## REVISED CERTIFICATE OF OPERATIONAL ACCEPTANCE

Developer/Client: Suburban Land Agency | ACT Government  
Address: 480 Northbourne Avenue, Dickson ACT 2602 | GPO Box 158 Canberra ACT 2601  
Contact: Simon Frowd  
Project Title: **COOMBS EDGEWORTH PARADE PLAYGROUND (Civil & Hard Landscapes only)**

LIST OF OUTSTANDING WORKS:

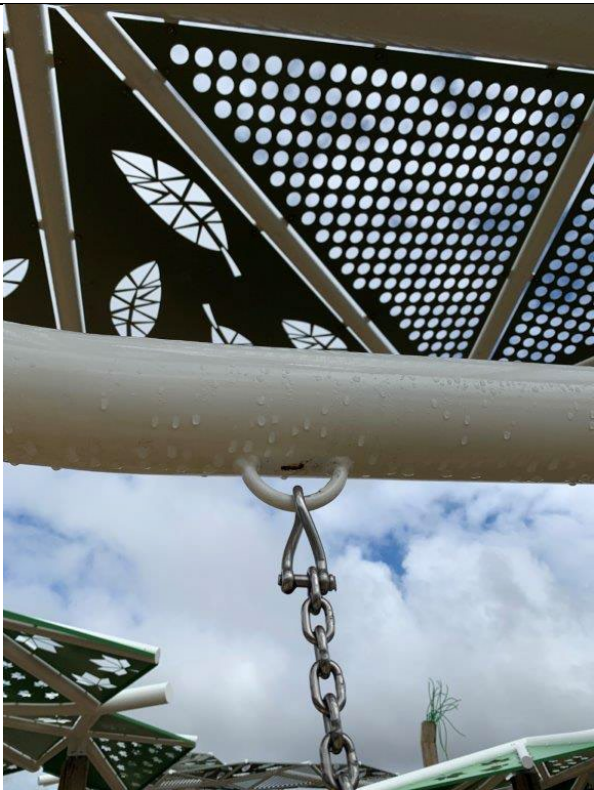
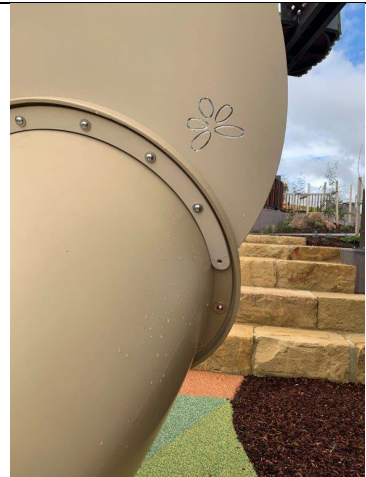
1.	Rocks close to path.	Open 27/09/22

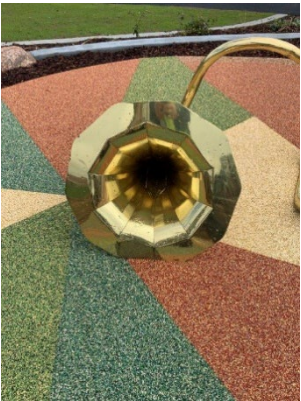
2.	Bolts protruding too far out on equipment.	
		Open 27/09/22
3.	Stop rusting and re-paint chipped areas. Swings	Open 27/09/22

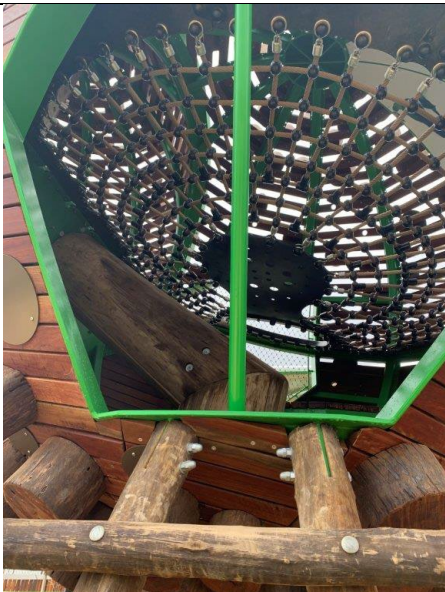
4.	Missing bolt on slide section.		Open 27/09/22
			Open 27/09/22
5.	Missing fixing on fence panel.		Open 27/09/22
